Model	Editor Board for PDC - 1E	Volt/Hz	Date of Modification	Serial Number
Modified Article	Editor Hinge and Mounting Bracket			
Reason for Modification	Parts catalog correction

Model		Editor board for PDC - 1E (-25, -27 only)						Volt/Hz	Date of Modification	Serial Number	
Modified Article		Intermediate Board									
Reason for Modification		To stabilize the 5V line level between the editor board add the PDC - 1E									
Draw No.	Old Parts No.		New Parts No.	Description	Rank	Q'ty Used Old → New	Inter-change-ability	Part needed for replacement by new part		Parts Catalog	
								Part No.	Description	No.	Page
			A9885517	Intermediate Harness		0 → 1				* 4	5
			A9885519	Intermediate Board		0 → 1				* 5	5

Model	Editor board for PDC-1E	Volt/Hz	Date of Modification	Serial Number
Modified Article	Original Pressure Pad			
Reason for Modification	To prevent the original pressure pad from deforming during transportation

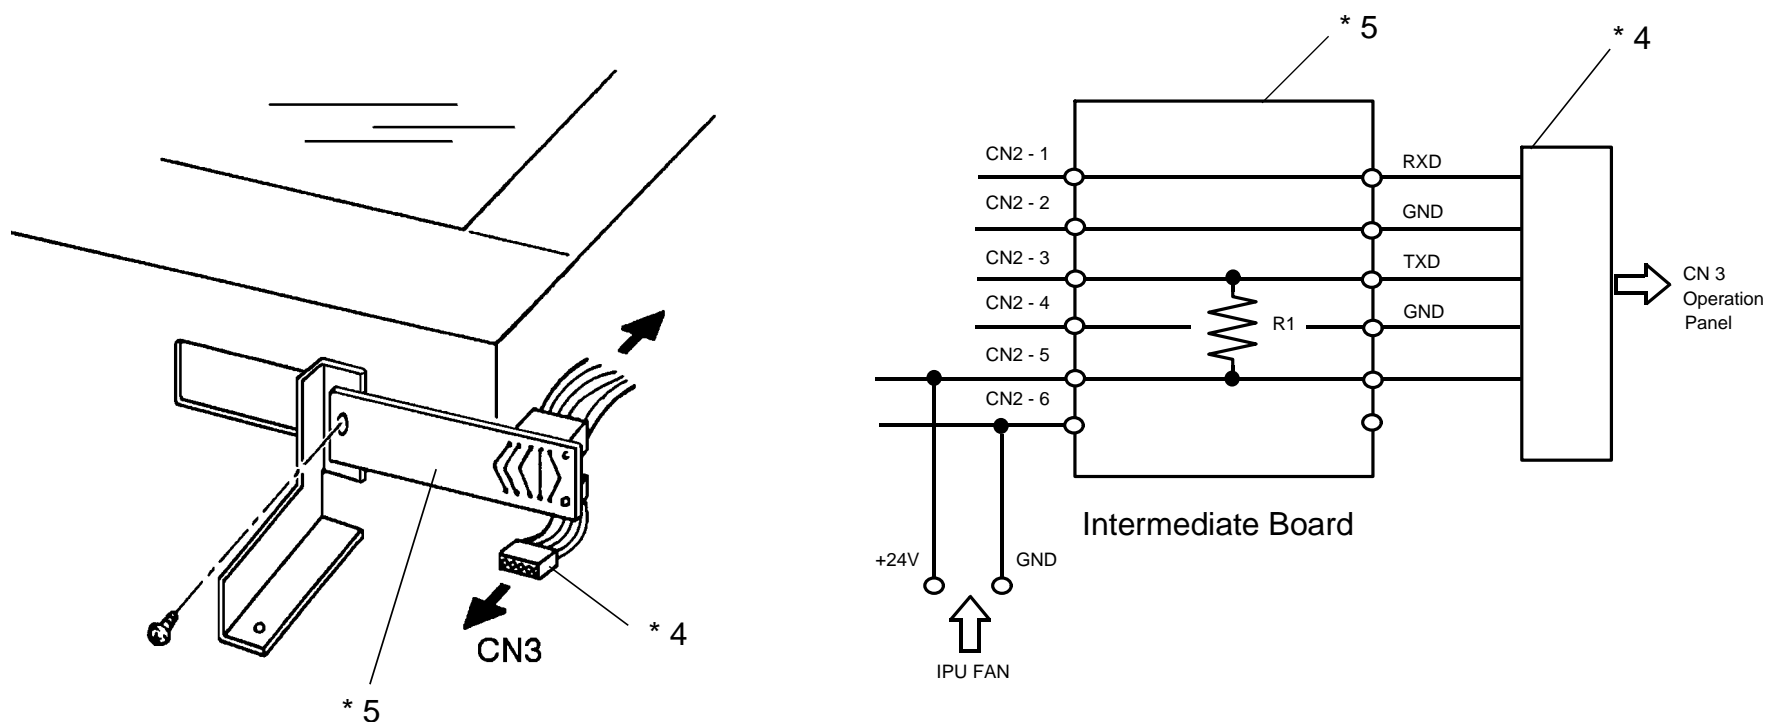
The level of Signal TXD (Editor → Copier) was not enough for being detected by the copier. So, some editor boards did not work at all. To solve this problem, we added an intermediate board [* 5] and an intermediate harness [* 4]. This board has 1 K OHM resistor on it and this resistor is connected between pin no.3 (TXD) and pin no. 5 (24V). So, the level of TXD is increased, to a sufficient level.
